OPERATING REGION
Thermal Power Limits of Specification
Figure 3.3-10-1
3.2.7.-1

WASHINGTON NUCLEAR - UNIT 2

Figure 3.2.1-3

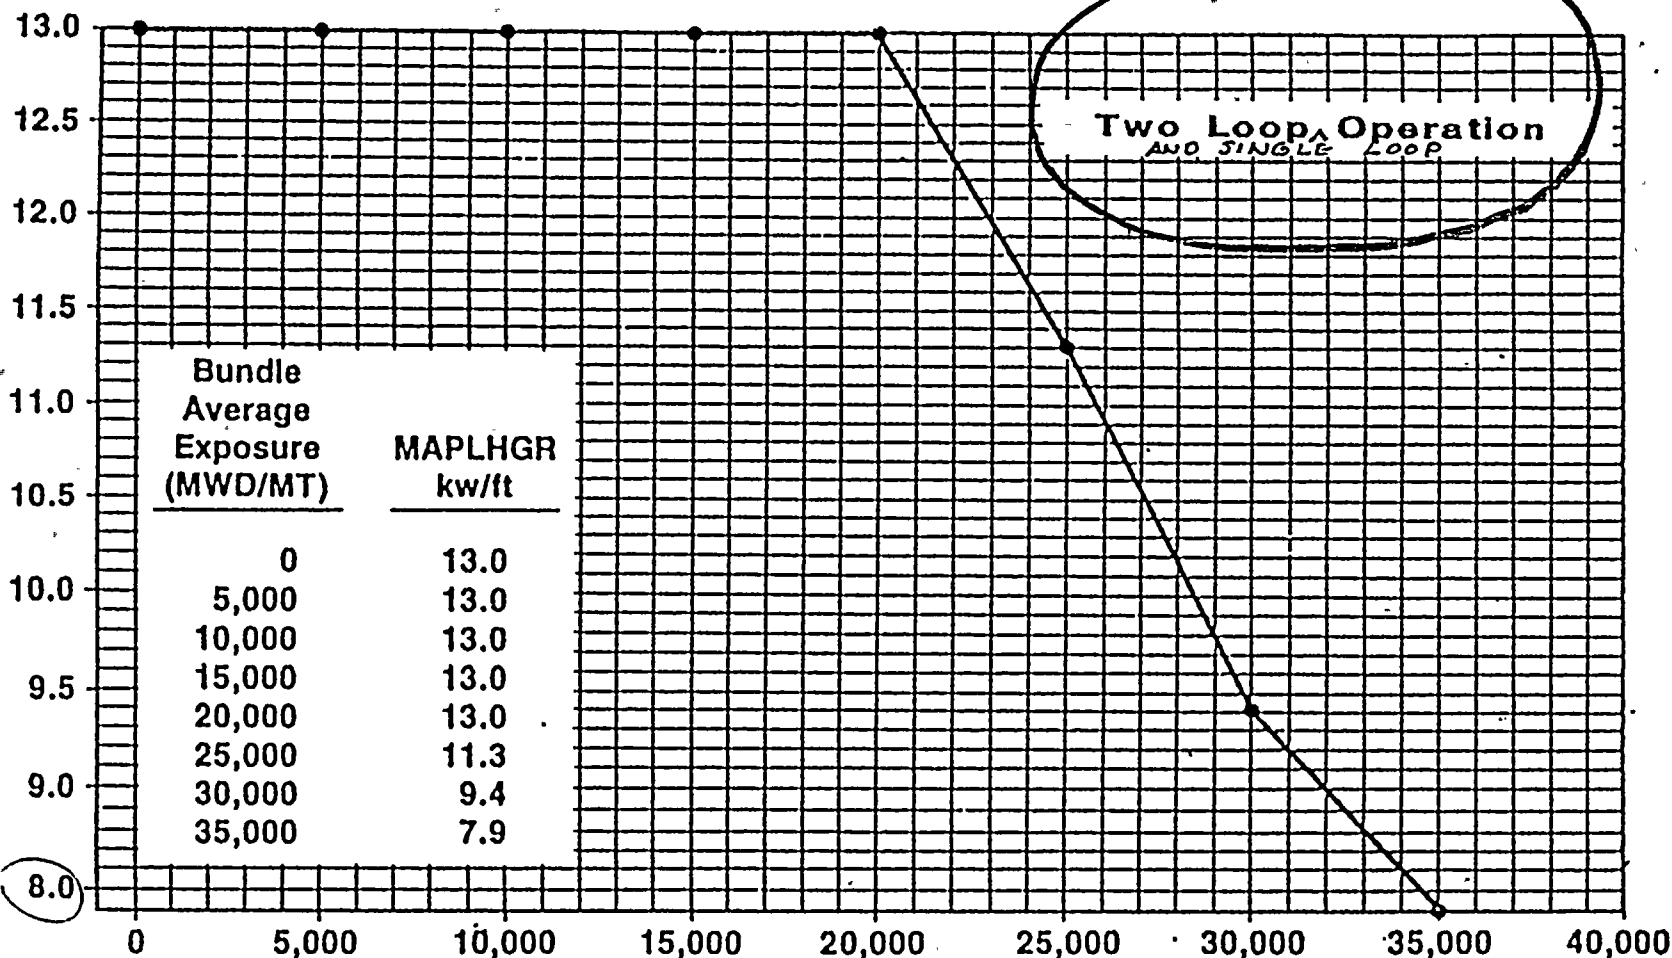
ADD

Operating Region
Thermal Power Limits of Specification
Figure ~~3.2.6-1~~
3.2.6-1

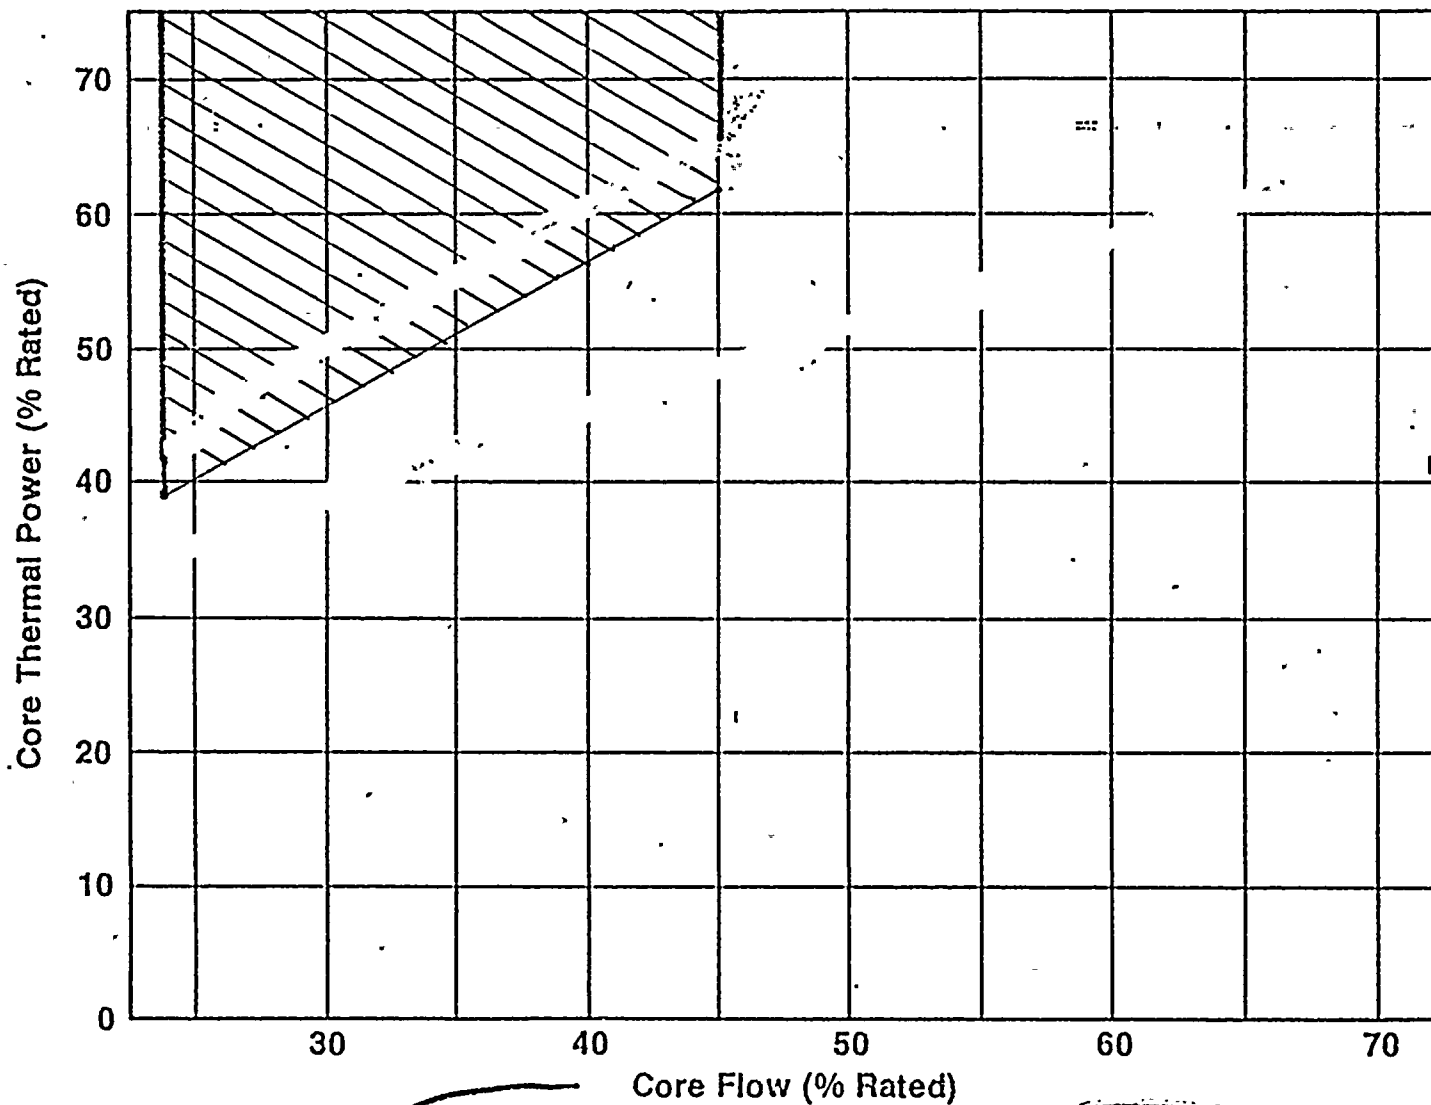
~~3.2.6-1~~

~~Amendment No. 1~~
